**REMARKS**

Applicants acknowledge with appreciation that the Examiner has allowed claims 1-3 and 5-13, and indicates that claim 4 would be allowable if rewritten to overcome the indefiniteness rejection. Applicants are amending claims 1, 3, 7, and 13. Therefore, claims 1-13 currently are pending in the above-captioned patent application and are subject to examination. Reconsideration of the above-captioned patent application is respectfully requested in view of the foregoing amendments and the following remarks.

FIG. 7

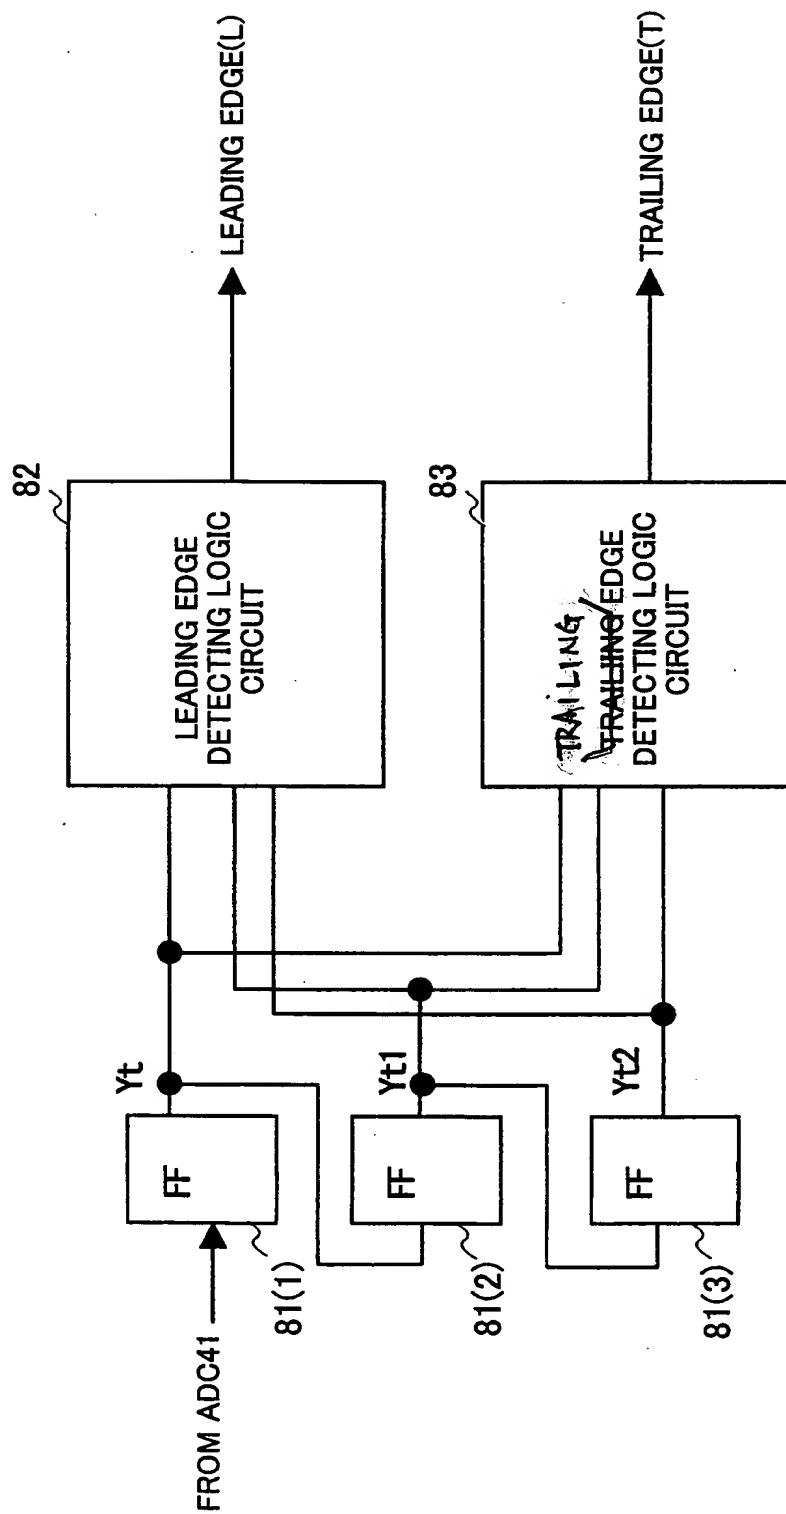
In the Office Action mailed April 26, 2004, the Examiner objected to the drawings as allegedly including informalities. Applicants have amended Figures 7, 9, 13, and 18 in accordance with the Examiner's suggestions. Therefore, Applicants respectfully request that the Examiner withdraw the objections to the drawings.
